Attention:
Village of Bayside, WI
Architecture Review Committee

PROJECT/SITE OWNER: Daniel Kleindl PROJECT ADDRESS: 375 E. Brown Deer	PROJECT SUMMARY: New fence; Black aluminum finish 150 foot in length 5-foot high
--	--

VILLAGE CODE REVIEW

HEIGHT:

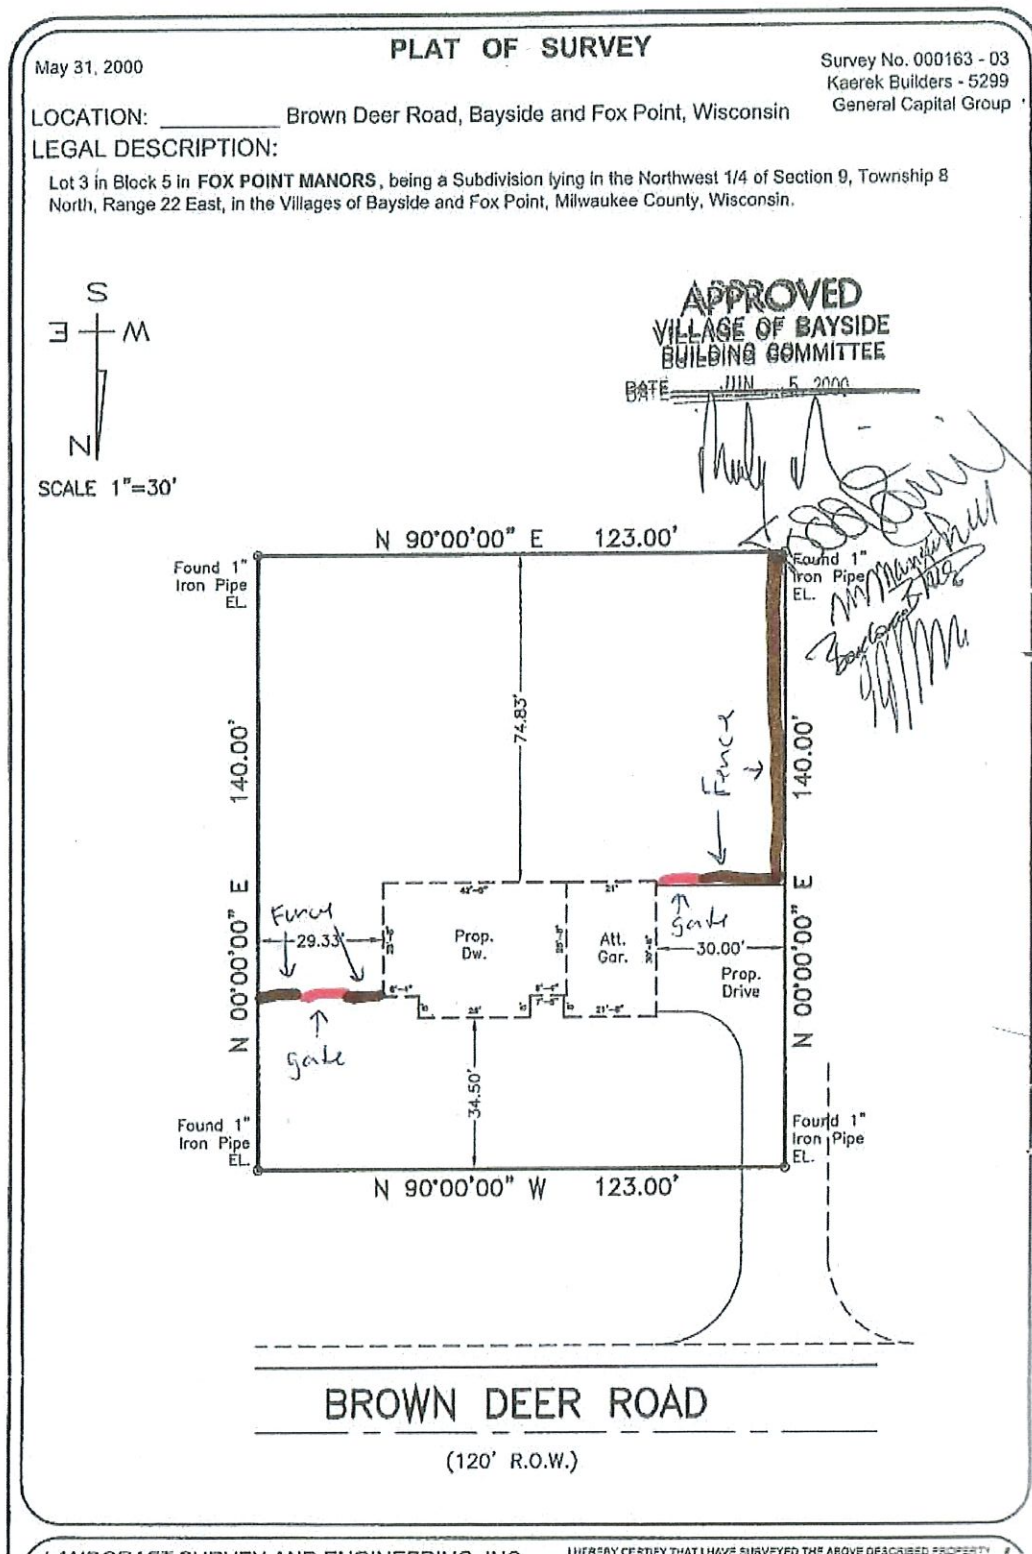
PROPOSED 5 FOOT HEIGHT IS COMPLIANT
